**Commonwealth Edison**

September 18, 1981

Subject: Byron Station Units 1 and 2  
Braidwood Station Units 1 and 2  
Responses to FSAR Questions  
NRC Docket Nos. 50-454, 50-455,  
50-456 and 50-457

ATTACHMENT A

Figure Q362.7-1

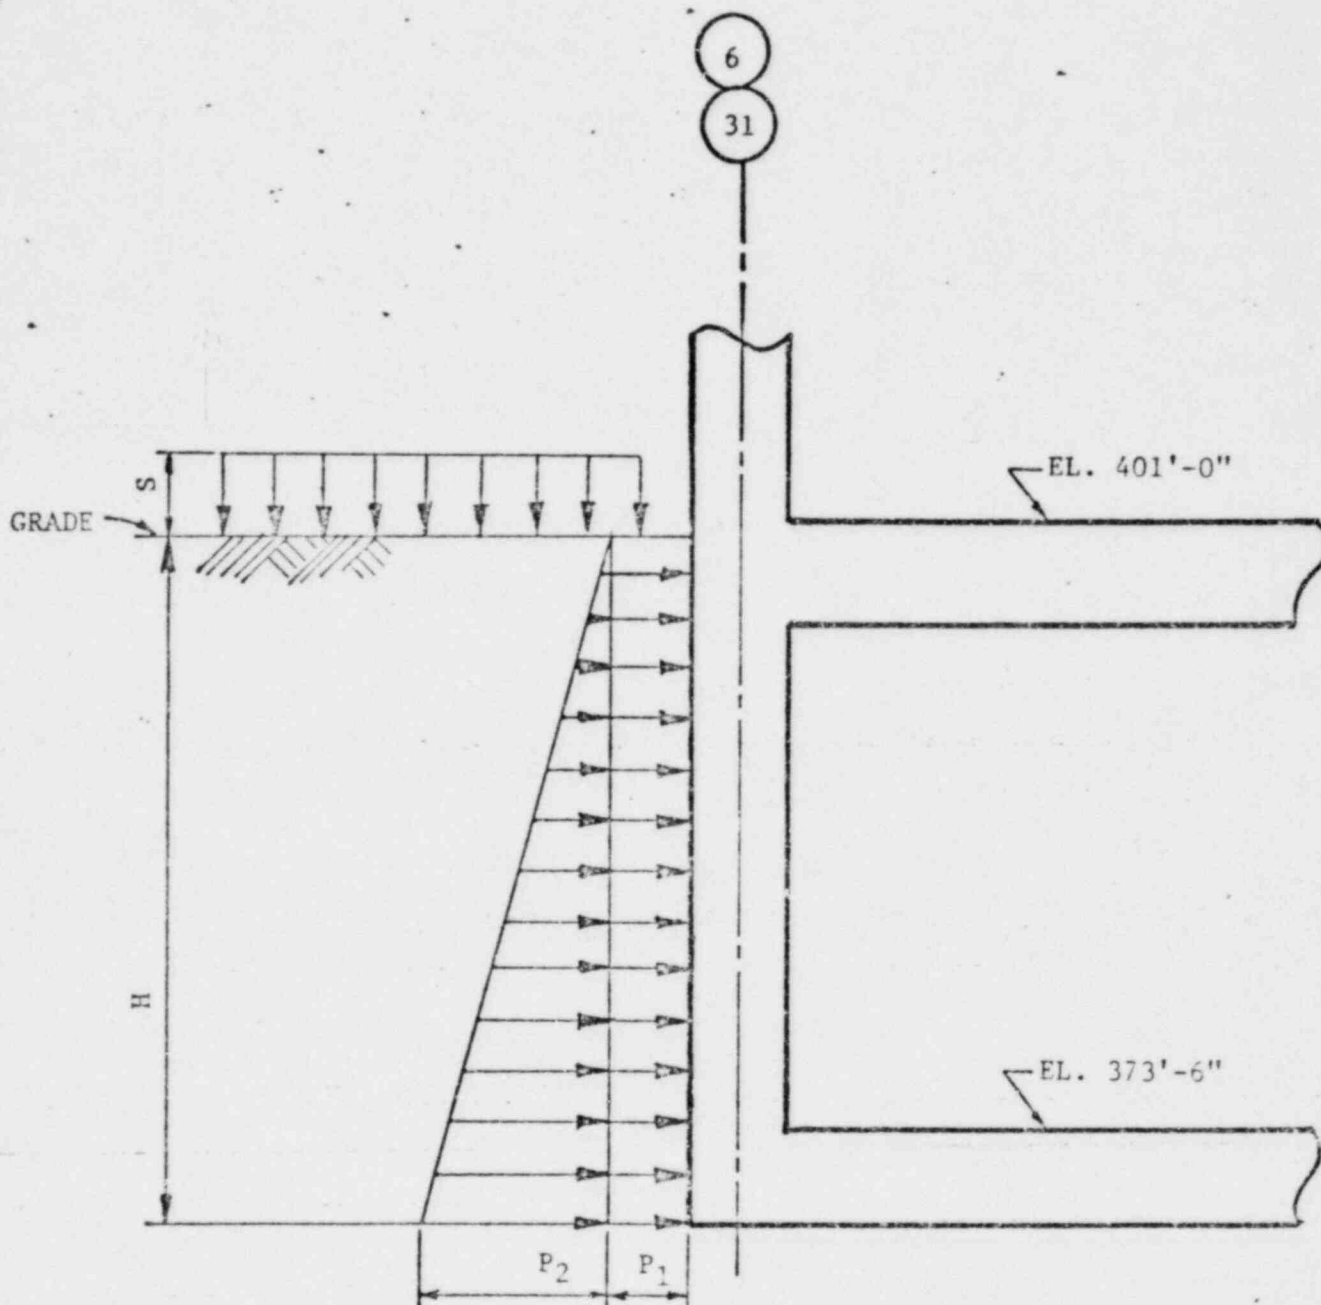
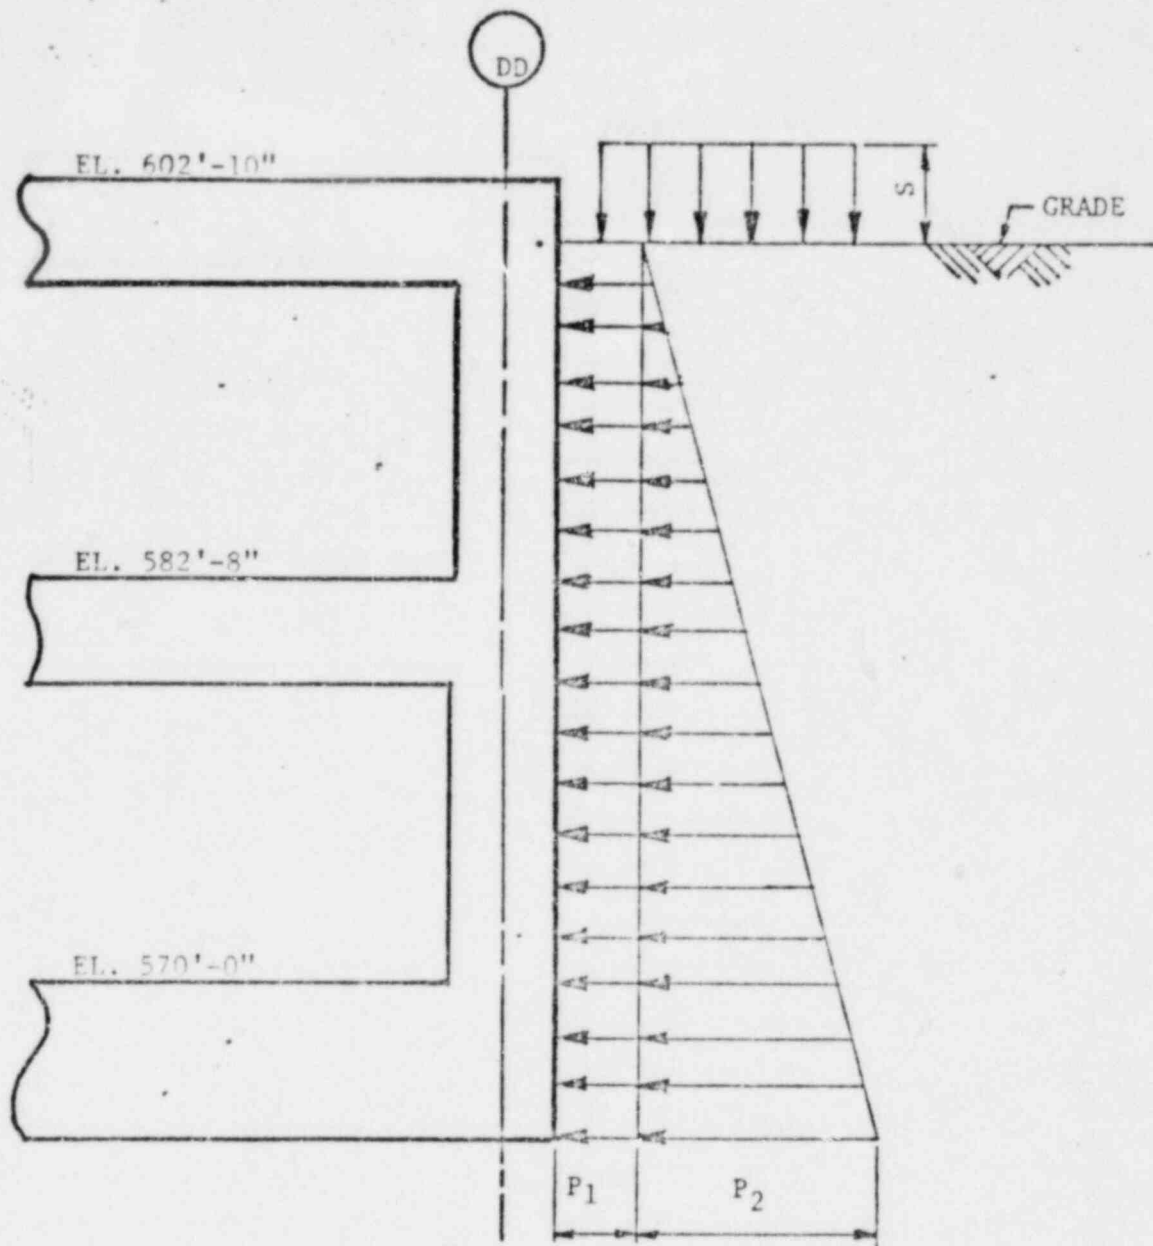
Figures Q362.7-1 and Q362.7-2 detail the lateral earth pressure plots versus depth for the auxiliary building and the lake screen house. Hydrostatic pressure on Category I structures are computed as detailed in Braidwood FSAR Subsection 2.5.4.10.1.3.1. The total static lateral pressure was obtained by combining soil and hydrostatic pressures. The response to FSAR Question 362.7 concerns only lateral earth pressure under static conditions.

BYRON/BRAZWOOD  
FSAR  
FIGURE 3.8-46  
CONTAINMENT BUILDING  
EAST-WEST SECTION

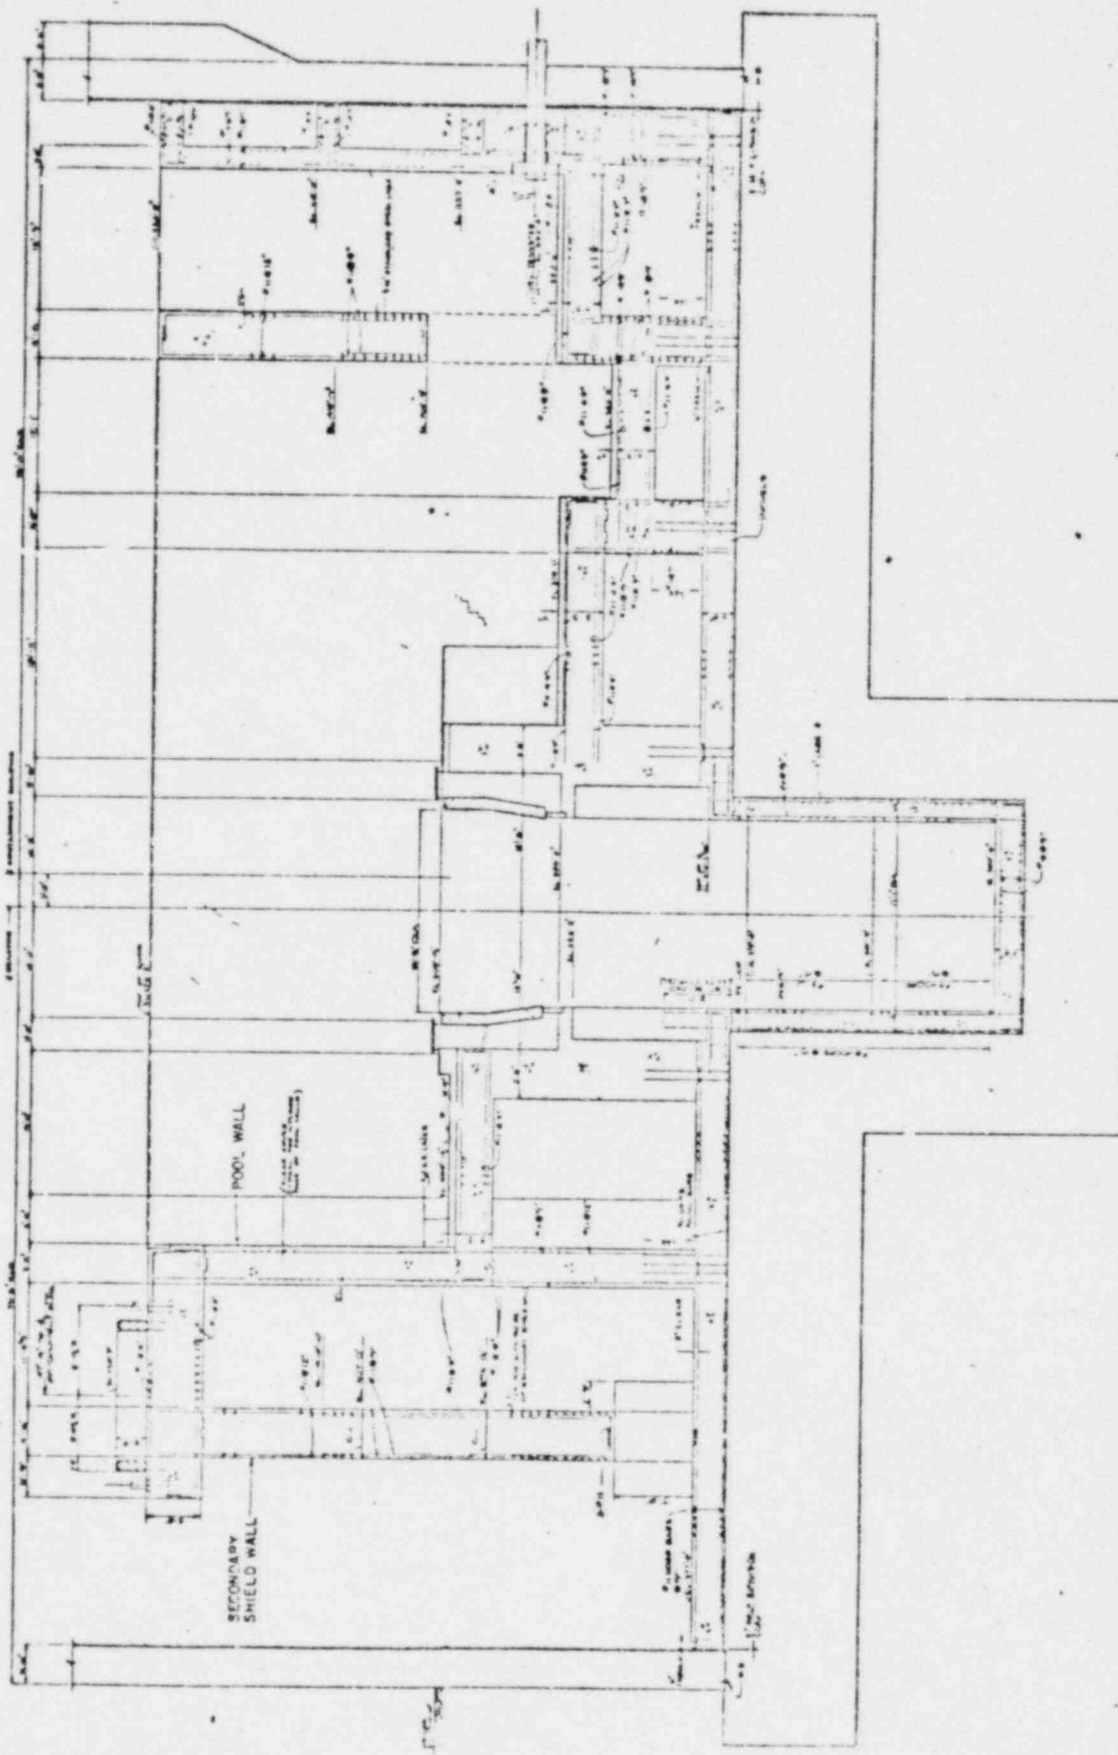
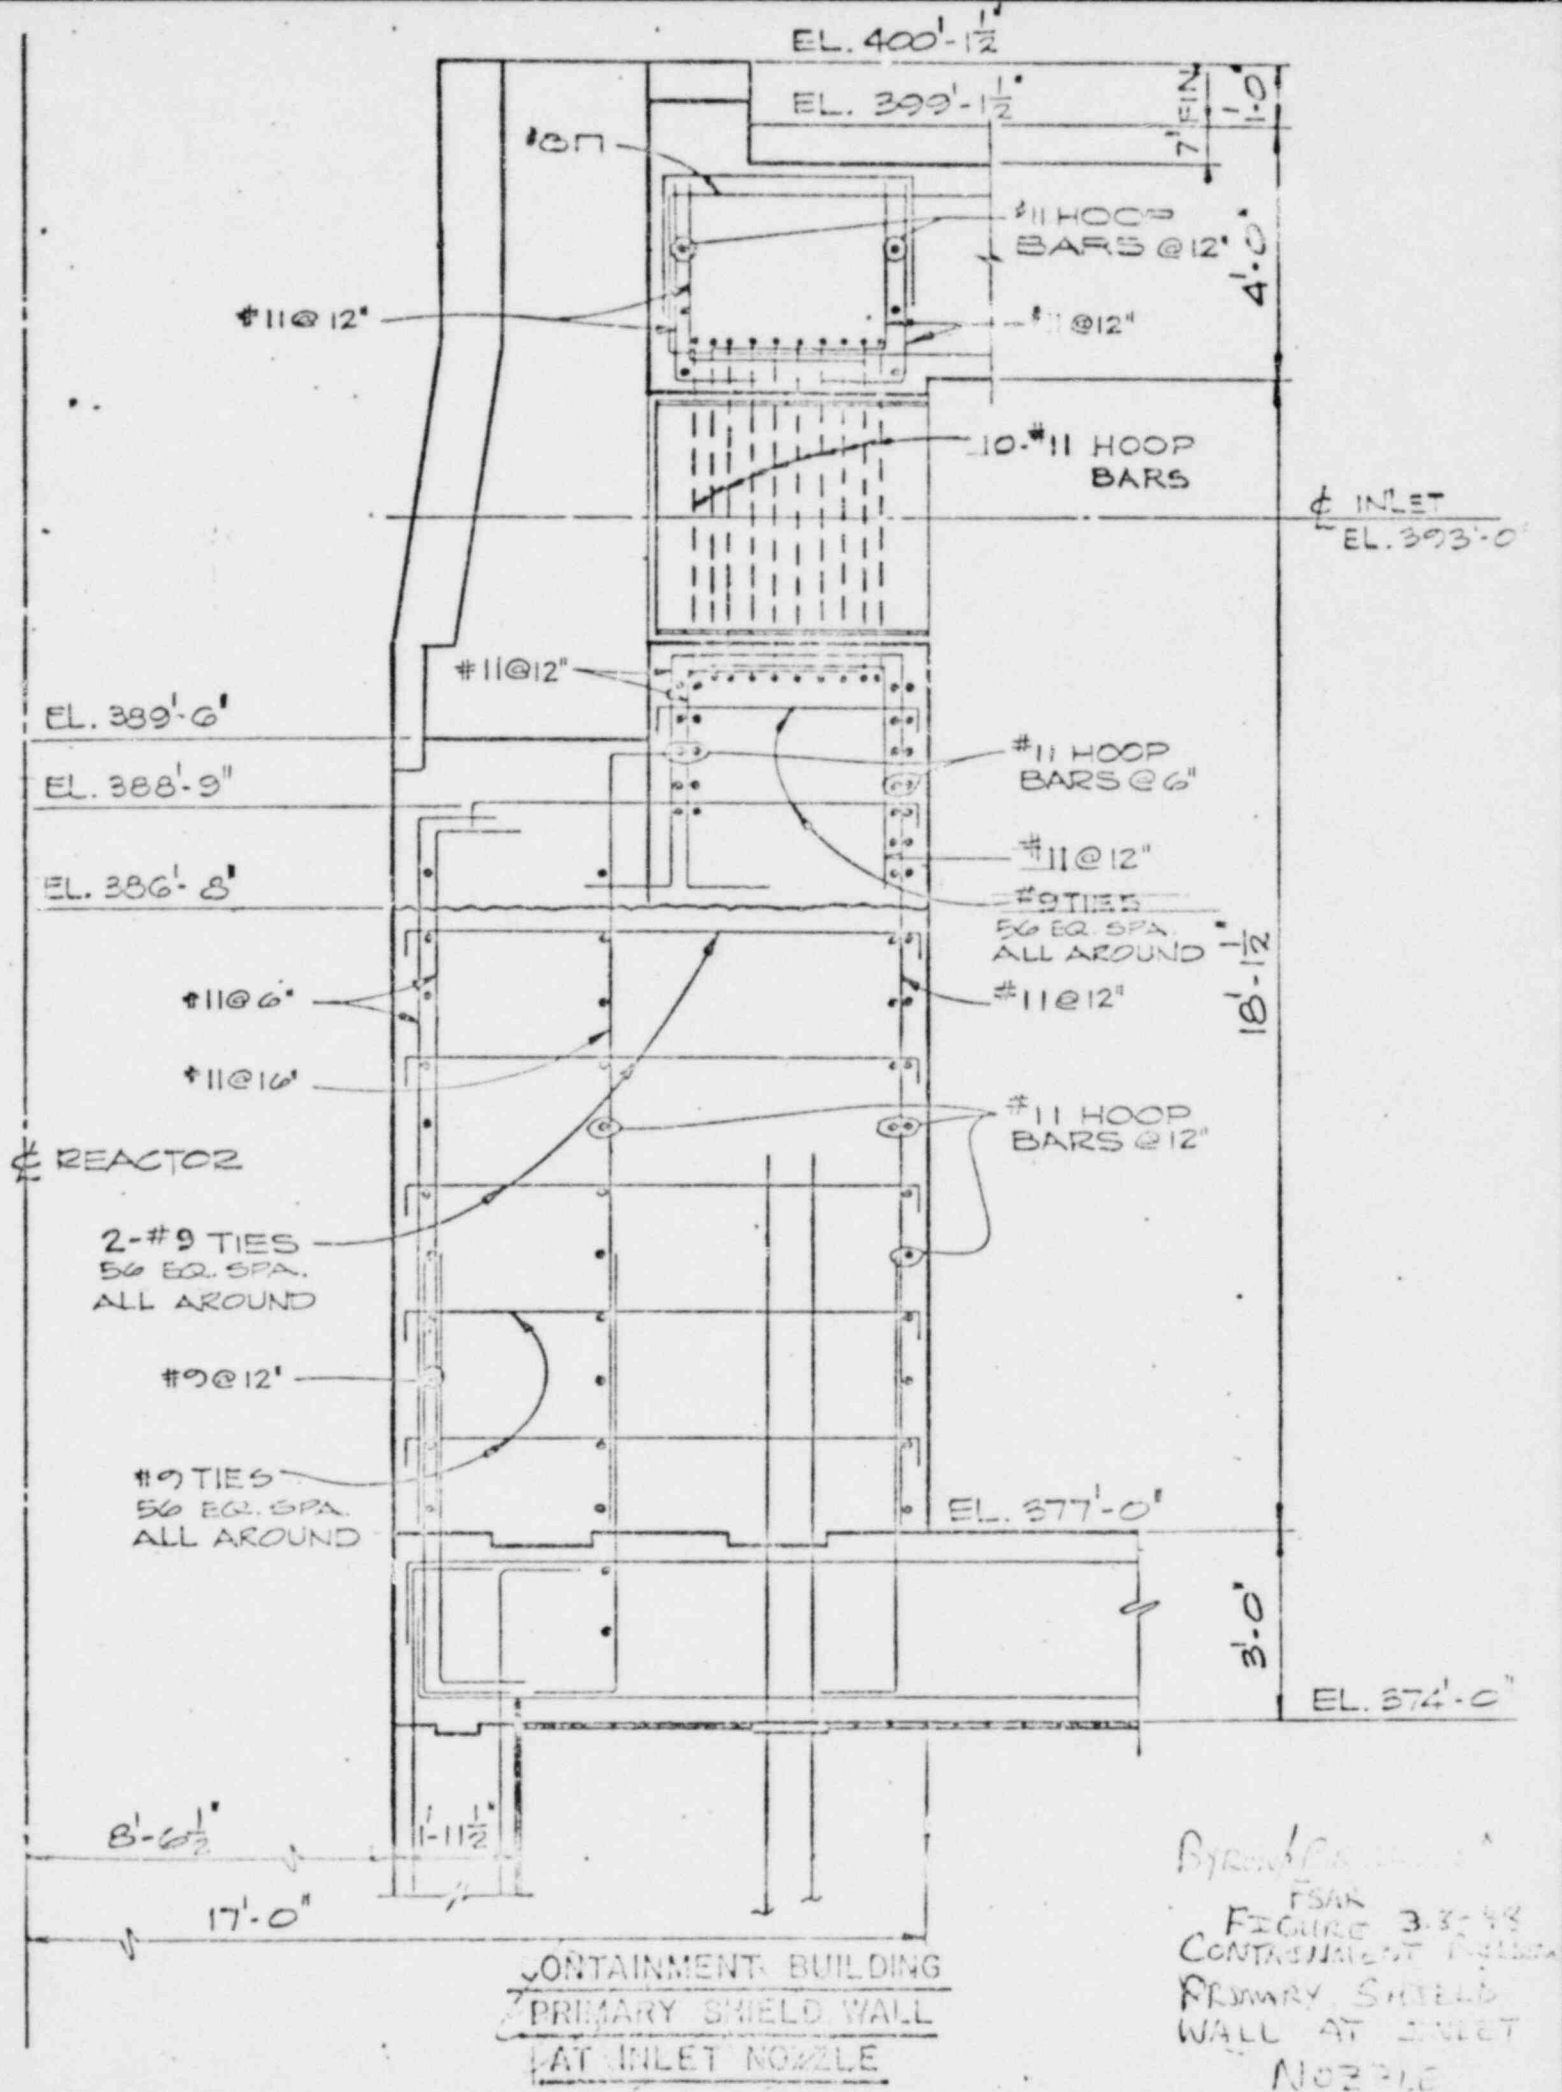
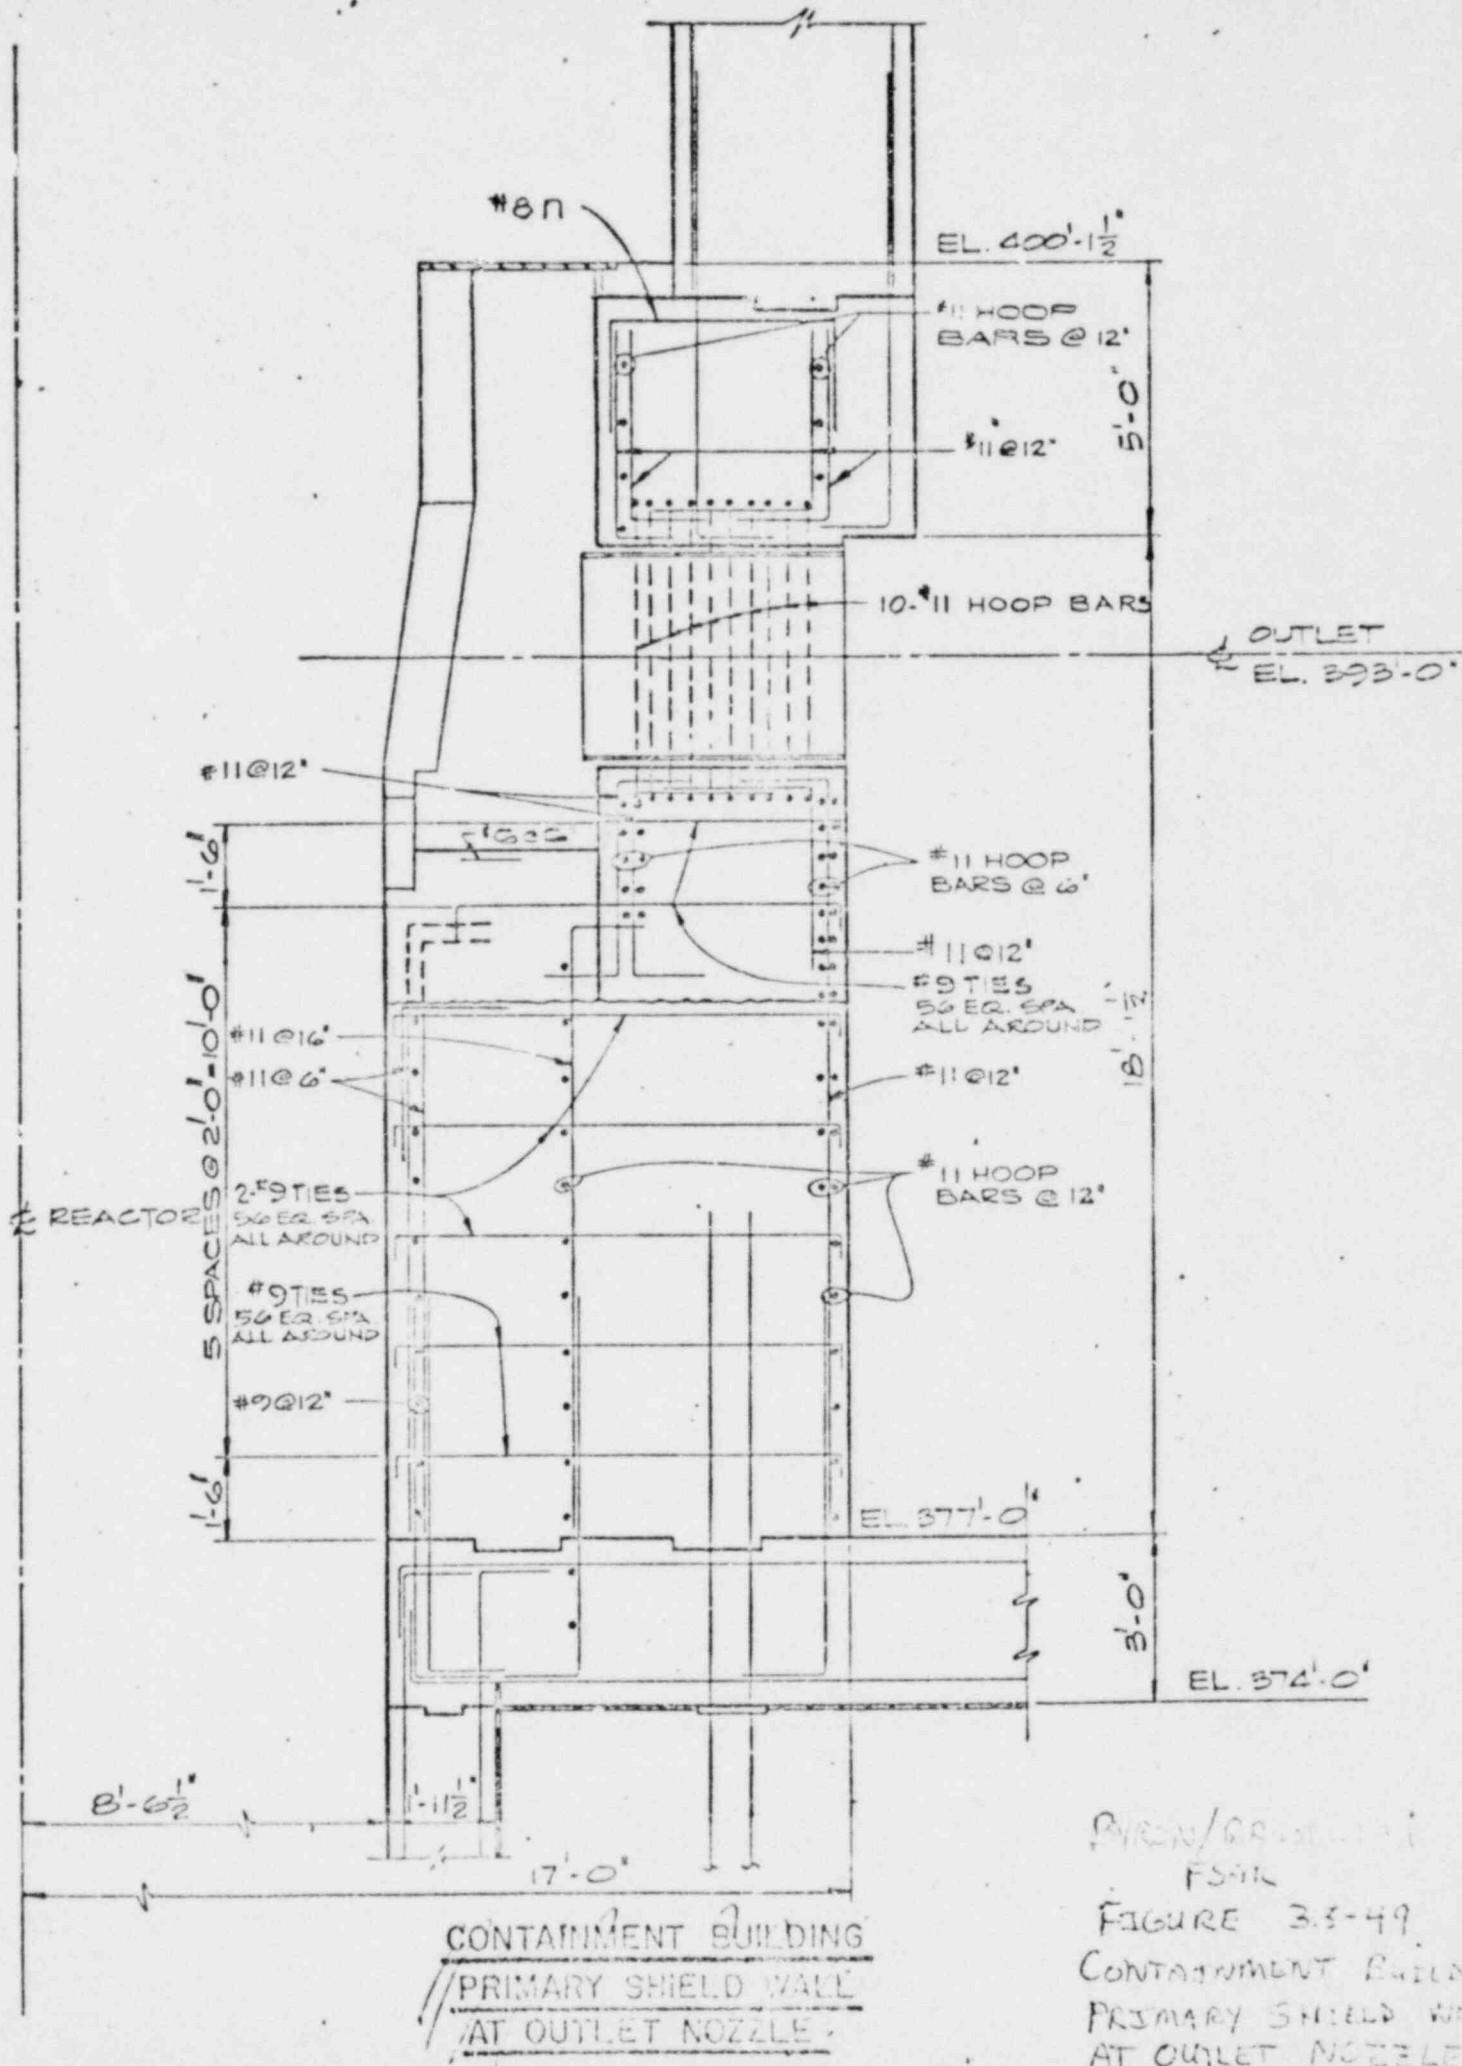
Containment building sections in the east-west and north-south directions, primary shield wall, and NSSS component enclosure plans are shown in new Figures 3.8-46 through 3.8-51. These figures, together with the descriptive information in Subsections 3.8.3.1.5 through 3.8.3.1.8 and Figures 3.9-4 through 3.9-9, define sufficient detail for a structural review of the containment internal structures.
